## 2. SITE CHARACTERISTICS

In Section 2.1.1.1 of the site safety analysis report (SSAR) for the Grand Gulf Nuclear Station (GGNS) early site permit (ESP) site, the applicant presented information concerning site location and site area that could affect the design of structures, systems, and components (SSCs) important to the safety of a nuclear power plant(s) falling within the applicant's plant parameter envelope (PPE) that might be constructed on the proposed ESP site.

**Figure 2.4-5 Grand Gulf ESP site vicinity map**

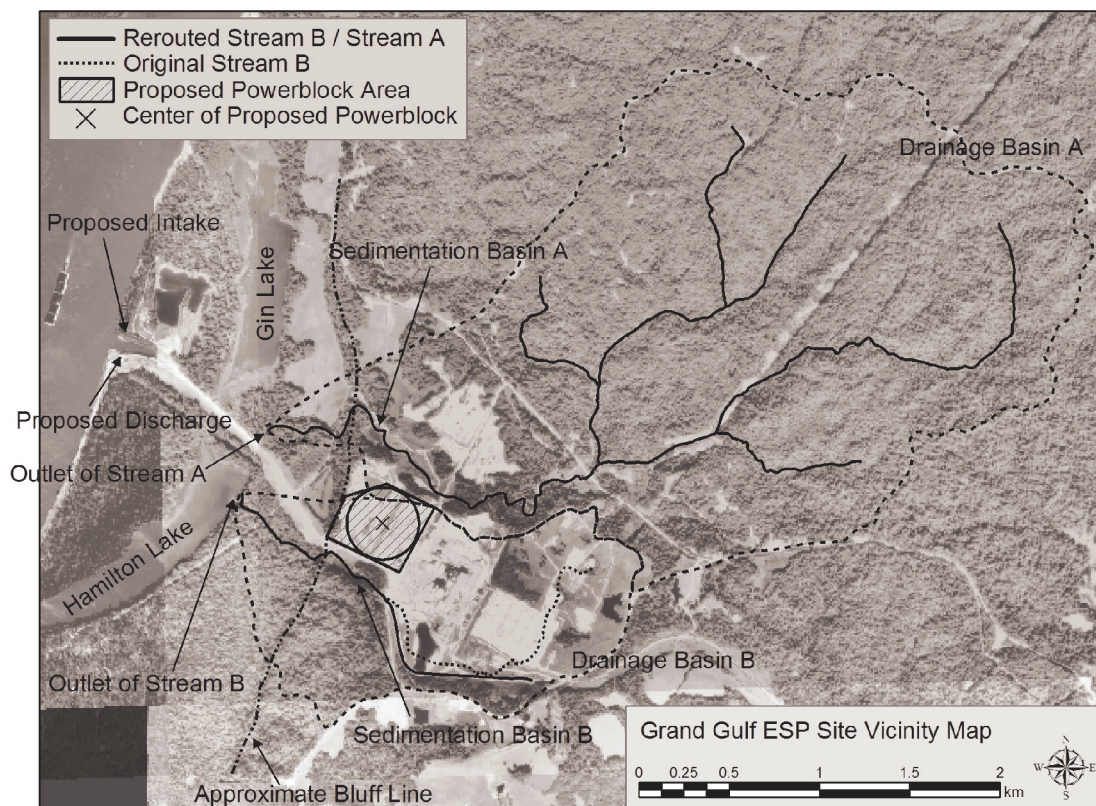
The staff's review of SSAR Figures 2.1-1 and 2.1-2 revealed that, although the coordinates inscribed on these figures for the center of the proposed powerblock are the same as those mentioned in applicant's response to RAI 2.4.1-1, the coordinates do not agree accurately with the position of the center of the proposed powerblock as drawn on these figures. The staff independently created a map to more accurately locate the center of the proposed powerblock. Figure 2.4-5 shows this map.

The map shown in Figure 2.4-5 uses the UTM Zone 15N North American Datum (NAD) 1983 geographic projection. As shown on SSAR Figures 2.1-1 and 2.1-2, the applicant's PPBA is located north of the heavy haul road, east of the bluffs, and southeast of the ESC building. The staff created the polygon labeled "Proposed Powerblock Area" on Figure 2.4-5 closely following the location of applicant's PPBA shown on SSAR Figures 2.1-1 and 2.1-2. The staff overlaid the largest circle that could fit inside the PPBA as shown in Figure 2.4-5. The staff assumed that the center of this circle represents the location of the center of the proposed powerblock. The UTM coordinates determined by the staff for the center of the proposed powerblock are N3,543,266.06 meters and E684,017.28 meters, with reference to the UTM Zone 15N NAD 1983 geographic projection.

The staff also overlaid the applicant-stated coordinates of the center of the proposed powerblock on the map and found that these coordinates place the proposed powerblock approximately 302 feet southwest of the staff-estimated coordinates mentioned above and closer to Stream B. Because of this discrepancy between the coordinates provided by the applicant and the plotted location of the powerblock on Figures 2.1-1 and 2.1-2, the staff cannot determine the actual location of the powerblock on the ESP site. Therefore, the staff required additional information on the true coordinates of the center of the powerblock. This was

Open Item 2.4-1. The staff intended to specify the coordinates of the center of the proposed powerblock as a permit condition subsequent to the satisfactory resolution of Open Item 2.4-1.

In response to Open Item 2.4-1 (Response to Request for Additional Information to Resolve the Grand Gulf Early Site Permit draft Safety Evaluation Report Open Items, System Energy Resources, Inc., June 21, 2005), the applicant stated that the UTM coordinates indicated in the SSAR, ER, and Environmental Policy Institute documents were inaccurate because of an error in a spreadsheet which was used to calculate UTM coordinates corresponding to Mississippi West grid coordinates. The applicant converted the coordinates of the center of the ESP powerblock, N550,099 feet and E277,346 feet in the Mississippi West grid coordinate system, to N3,543,261 meters and E684,018 meters in the UTM Zone 18 NAD 83 projection system using USACE software Corpscon Version 6.0. The applicant revised Figures 2.1-1, 2.1-2, 2.2-4, 2.4-1, 2.4-10, and 2.4-33 of the SSAR. The applicant also revised SSAR Sections 1.2, 2.1.1.1, and 2.4.1.1; Part 1, "Administrative Information," in Section 1.1; Part 4, "Emergency Planning Information," and Figures 2-1 and 2-3; and Section 2.1.1, ER Figures 2.1-1, 2.2-1, 2.3-1, 2.3-7, 2.3-12, and 2.3-20; and ER Sections 1.1, 2.1, 2.3, and 4.5.1 to include corrected UTM coordinates.
